ADDENDUM NO. 03

June 21, 2024

Additions and Renovations to Franklin Central High School Phase 2B
6215 S. Franklin Rd.
Indianapolis, IN, 46259

5 AHU T1 DETAIL
NOT TO SCALE

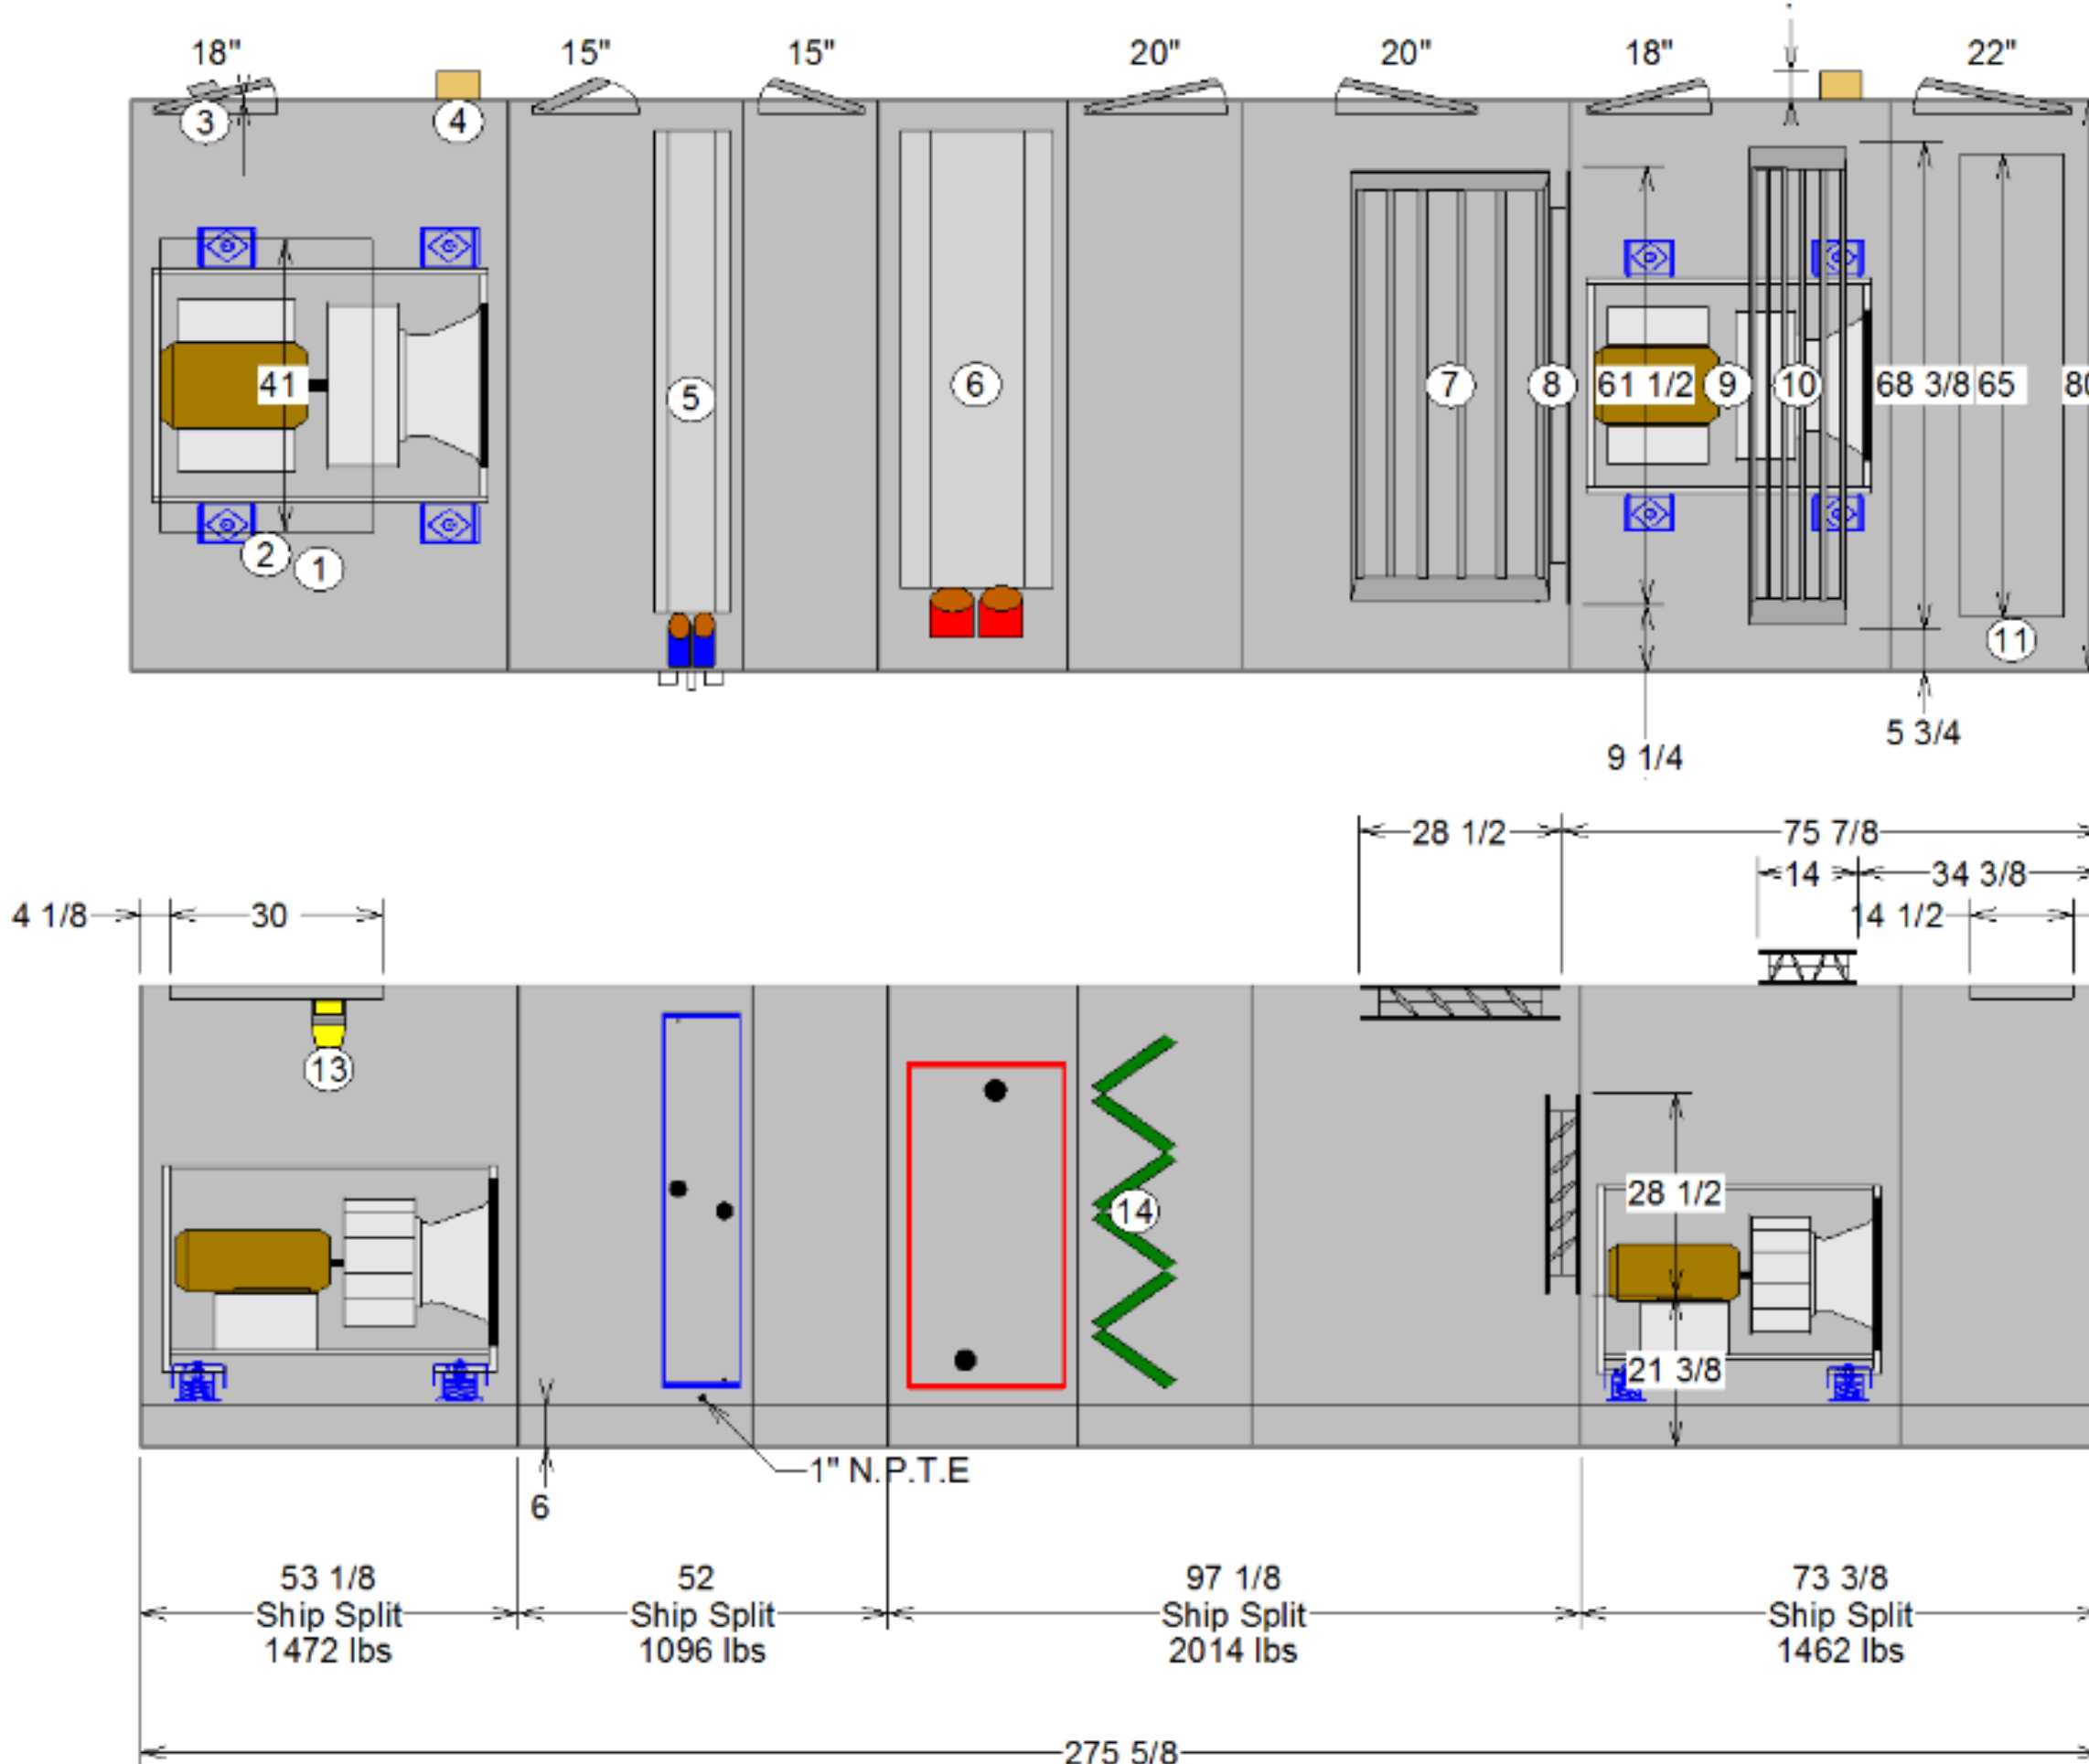
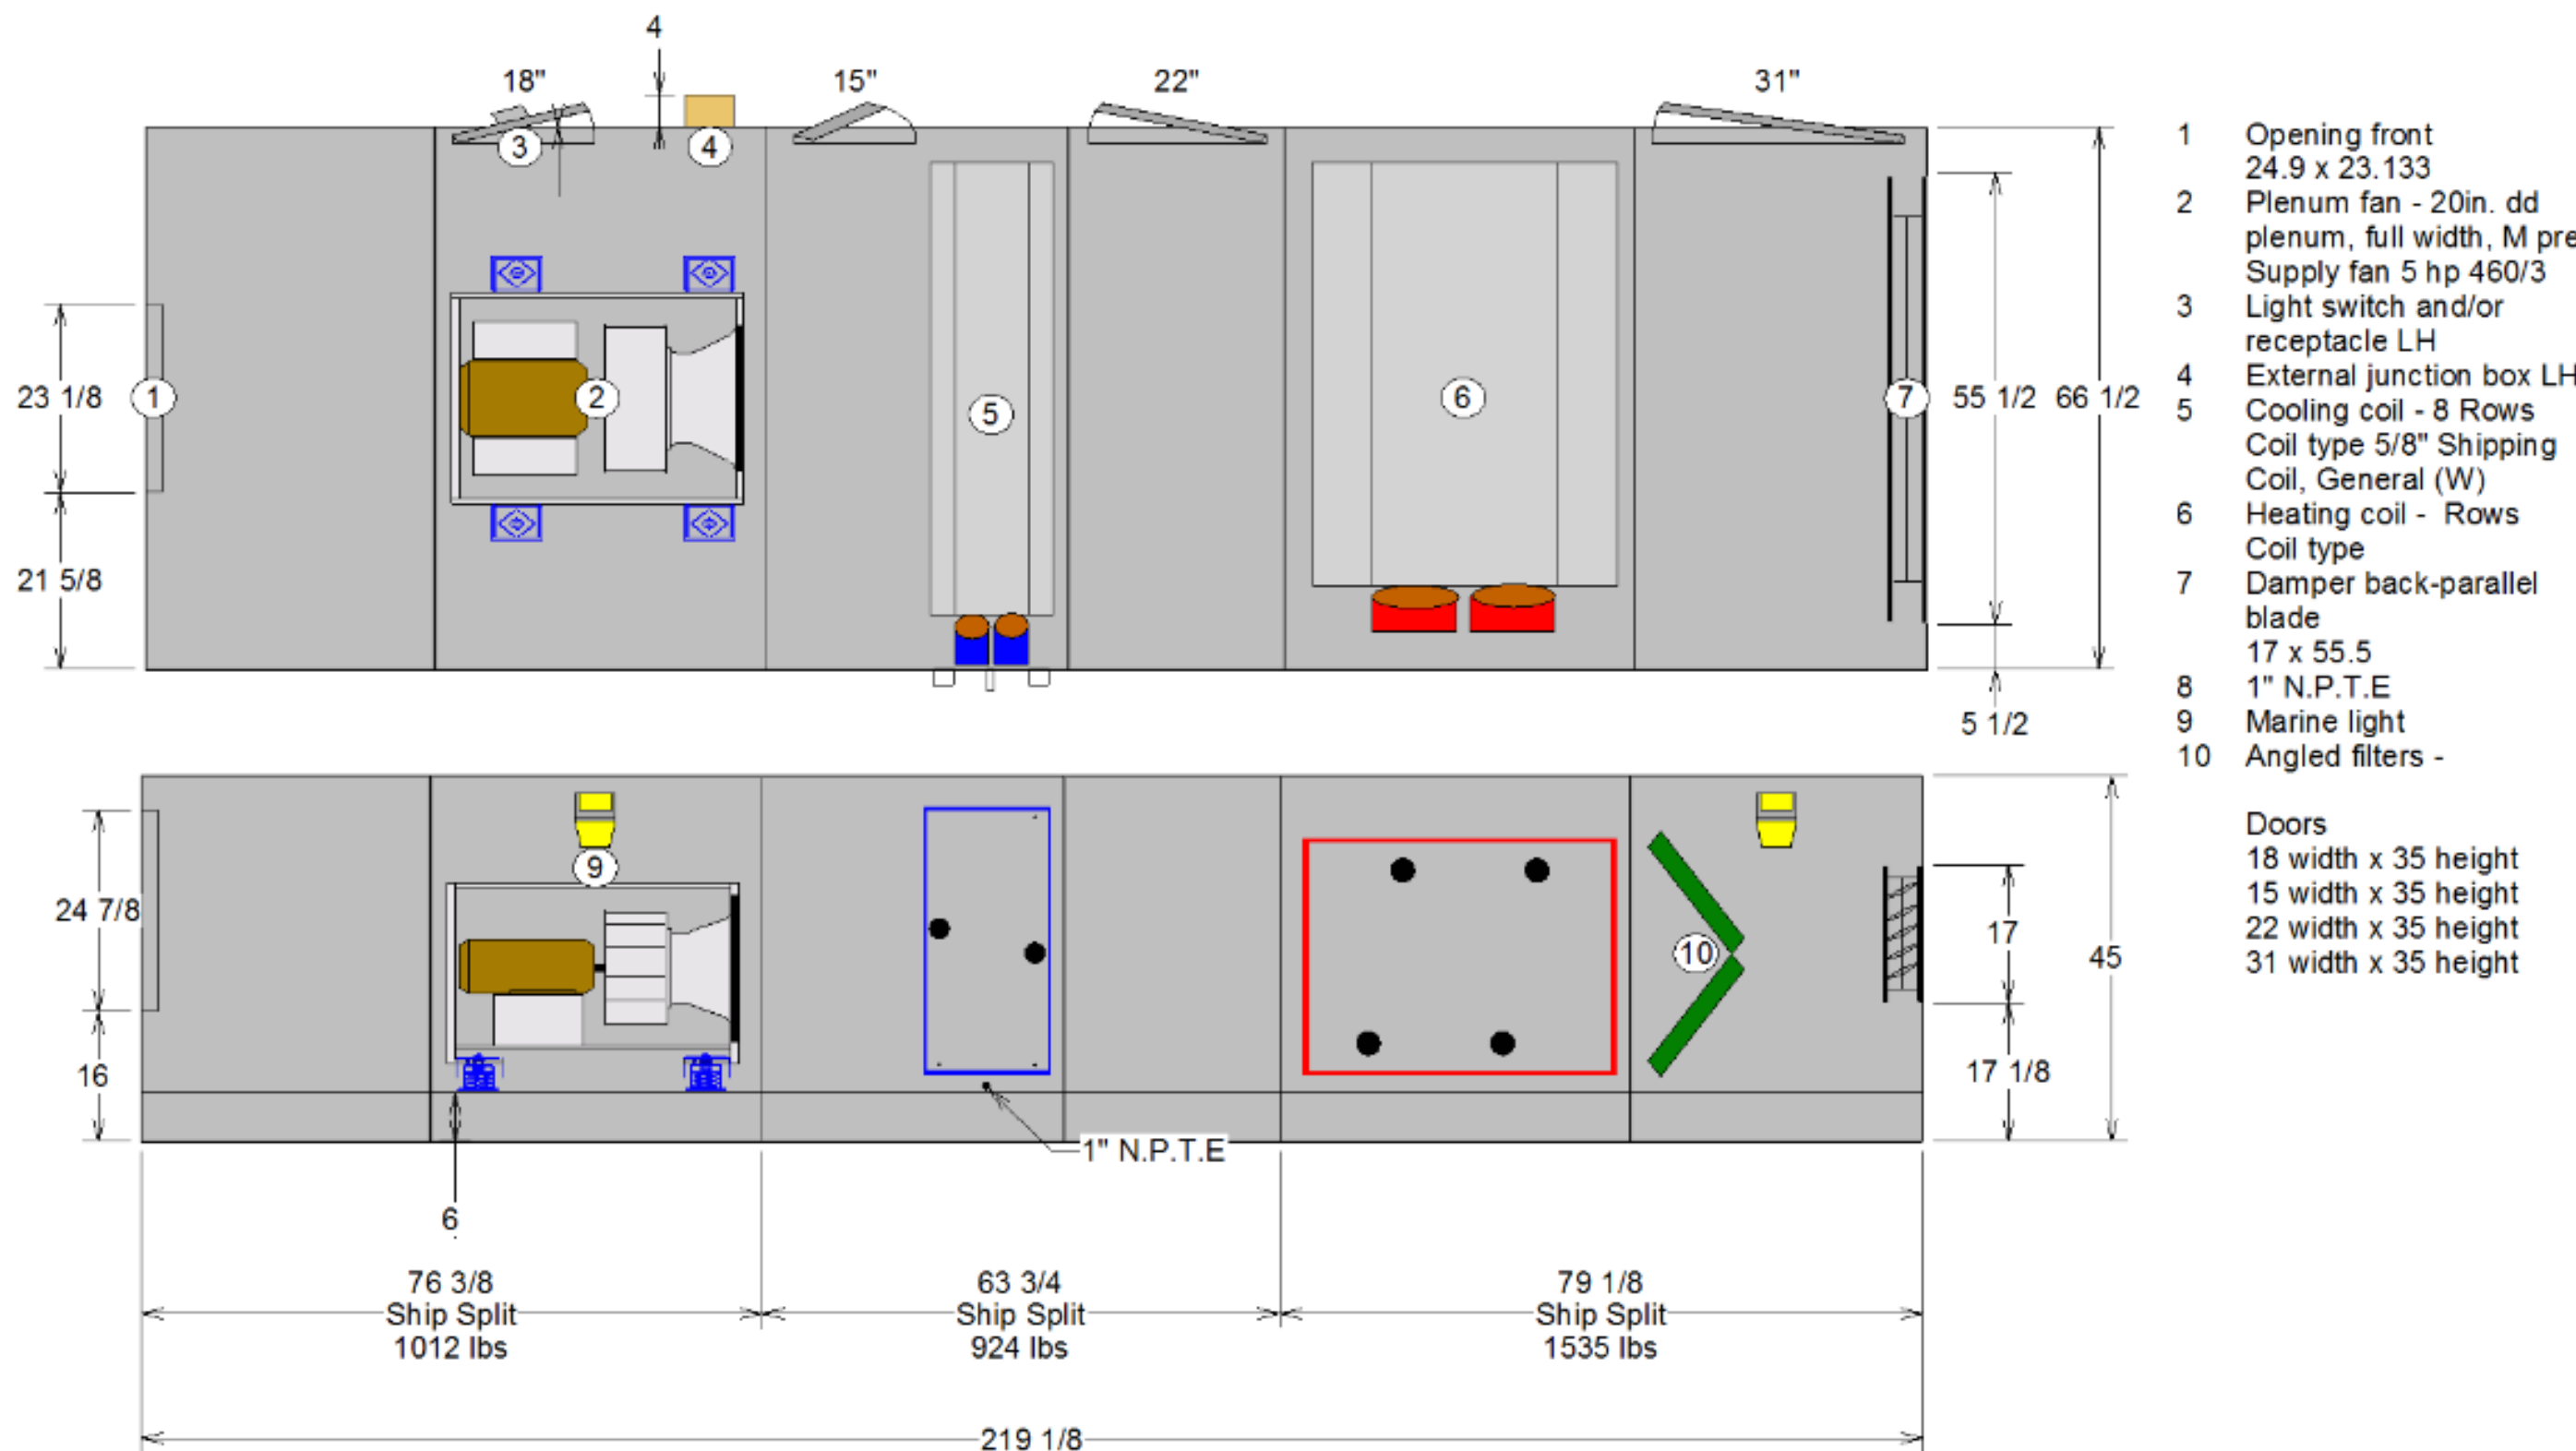
3-19 Section 237313.13 Indoor Basic Air-Handling Units: Revise Paragraph K.2 as follows:

1. DELETE AND REPLACE Paragraph K.2 in its entirety and replace with the following:

- a. Fabrication: Formed and reinforced, double-wall and insulated panels of same materials and thicknesses as casing.
- b. Hinges: A minimum of two ball-bearing hinges or stainless steel piano hinge and two wedge-lever latches, operable from inside and outside. Arrange doors as shown on details on drawings. Provide safety latch retainers on doors so that doors do not open uncontrollably.
- c. Gasket: Neoprene, applied around entire perimeters of panel frames.
- d. Size: Large enough to allow for unobstructed access for inspection and maintenance of air-handling unit's internal components. At least 12 inches wide by full height of unit casing up to a maximum of 60 inches"

Drawing No:
T201F

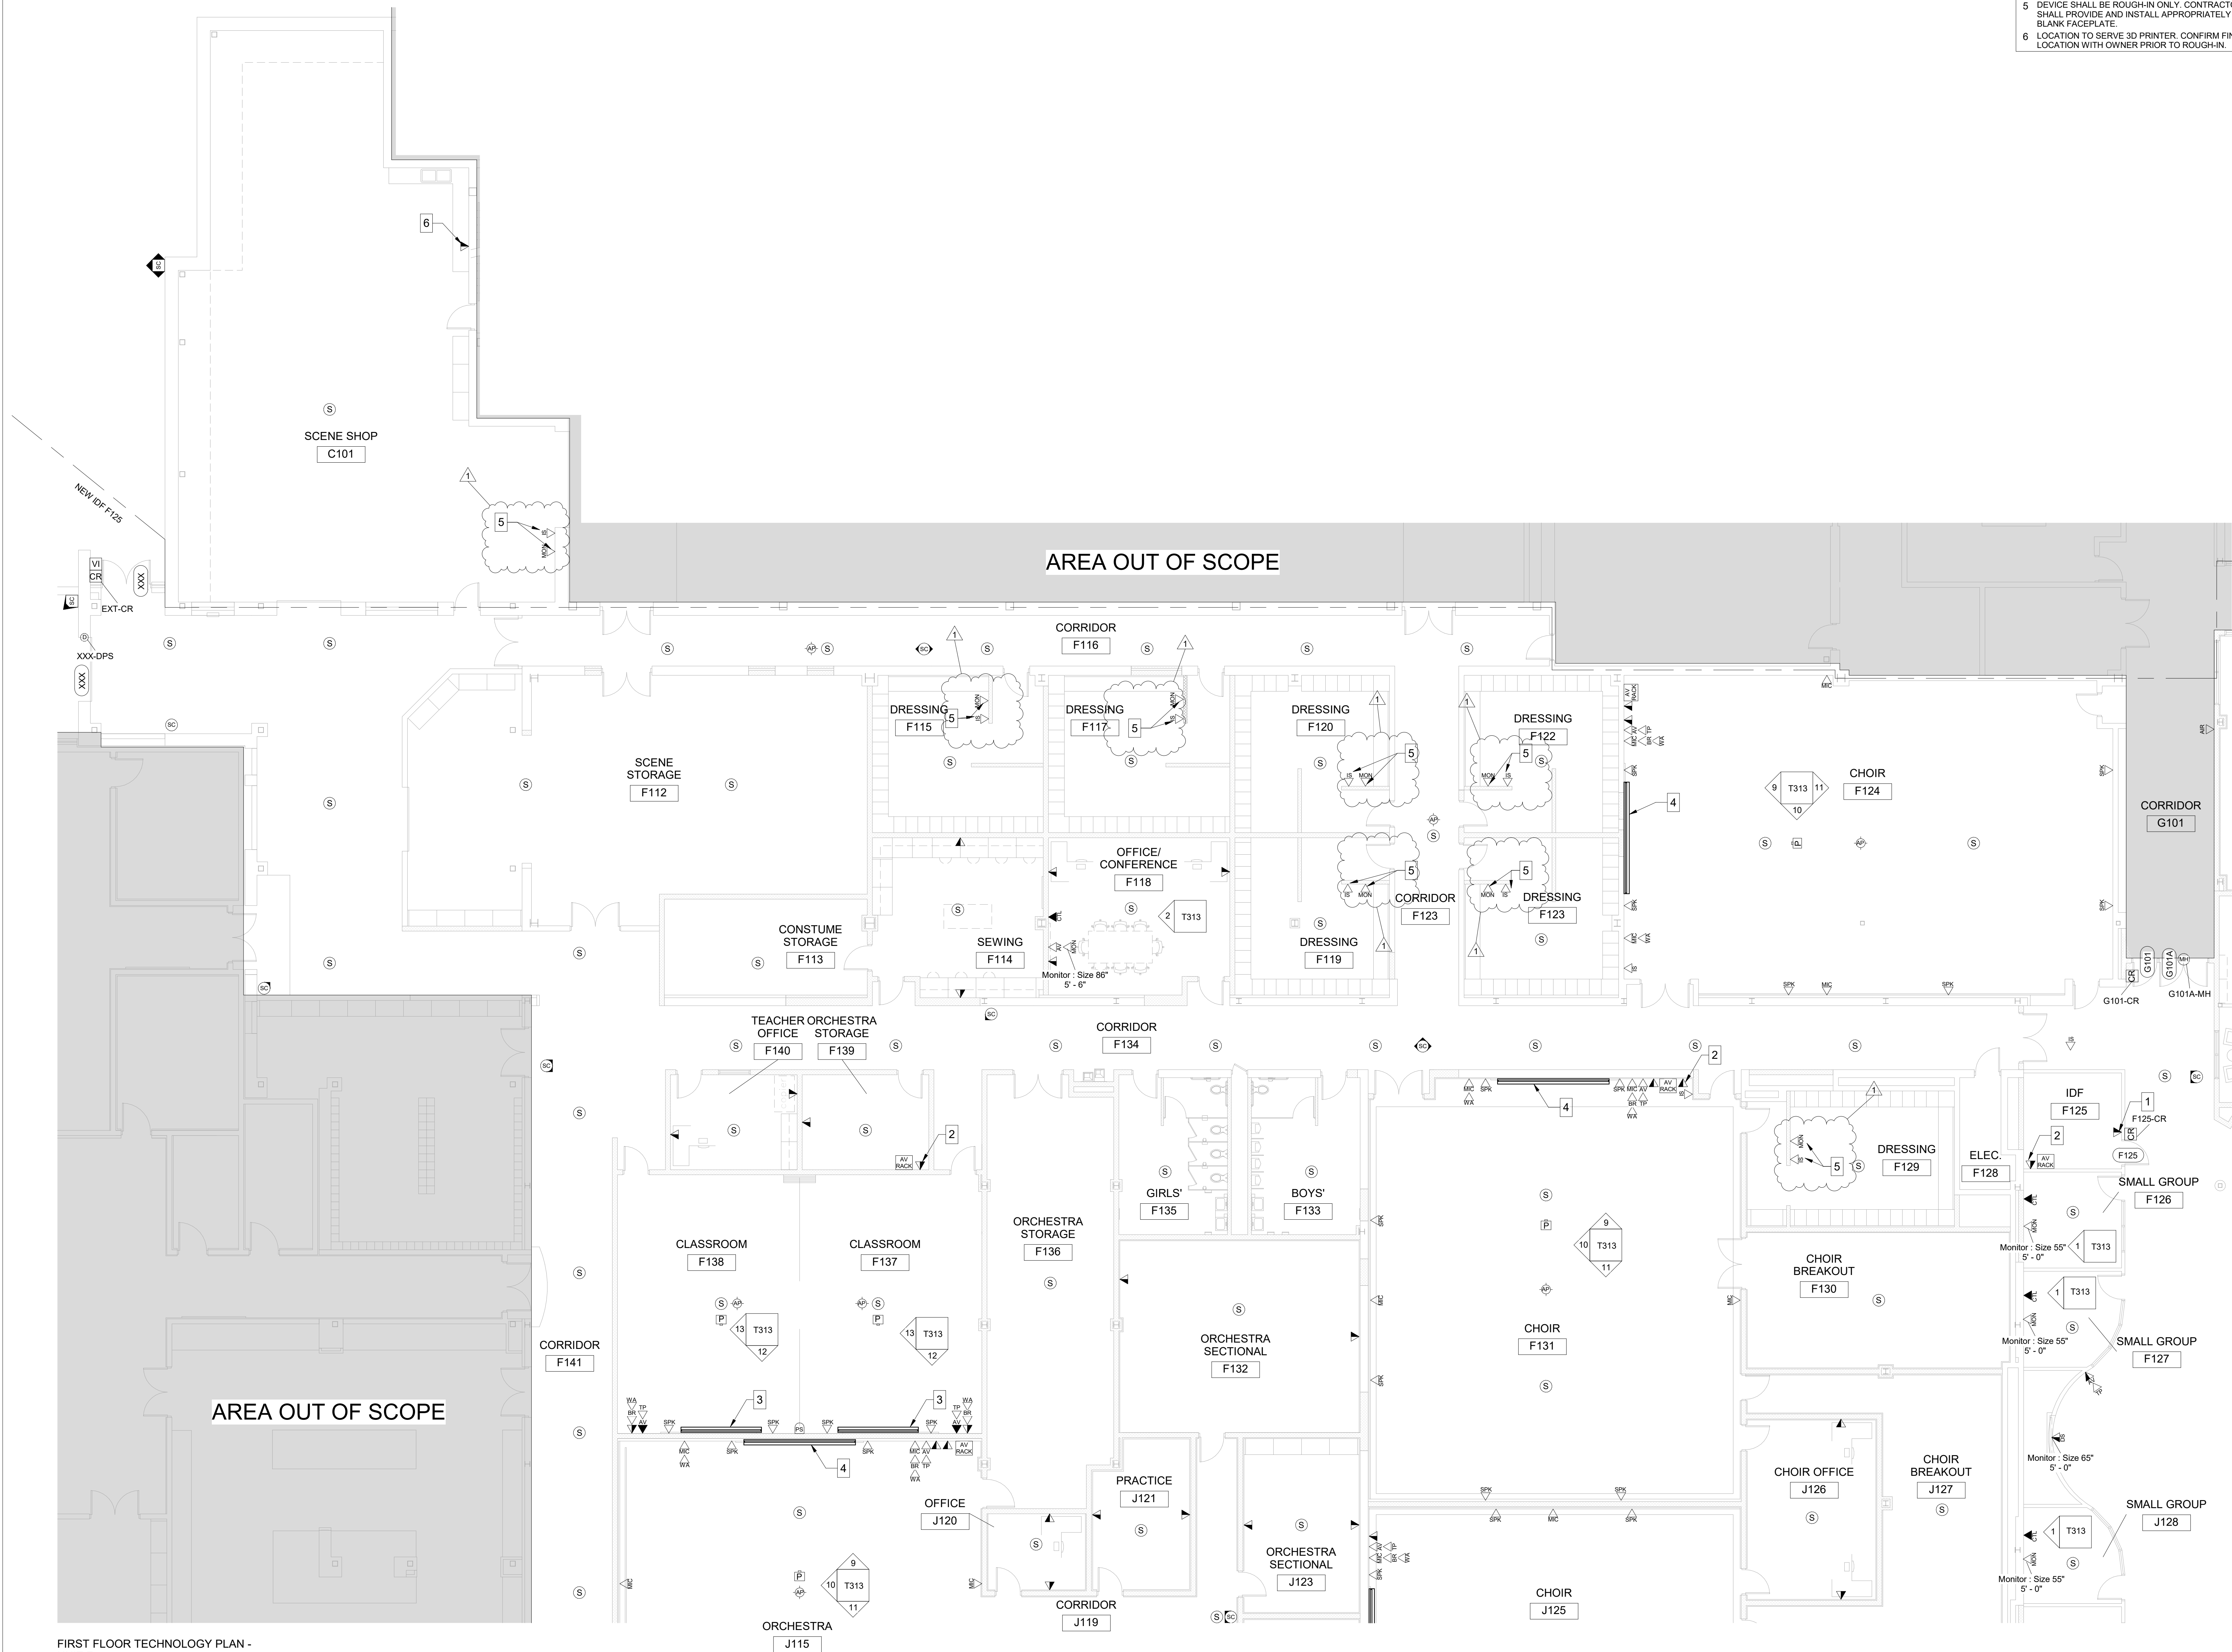
1. T201F – FIRST FLOOR TECHNOLOGY PLAN – UNIT F
 - a. Added intercom speaker station rough-ins.
2. T201J&M – FIRST FLOOR TECHNOLOGY PLAN – UNITs J&M
 - a. Added intercom speaker station rough-ins.
3. T305 – AV DIAGRAMs
 - a. Updated theater intercom diagram.
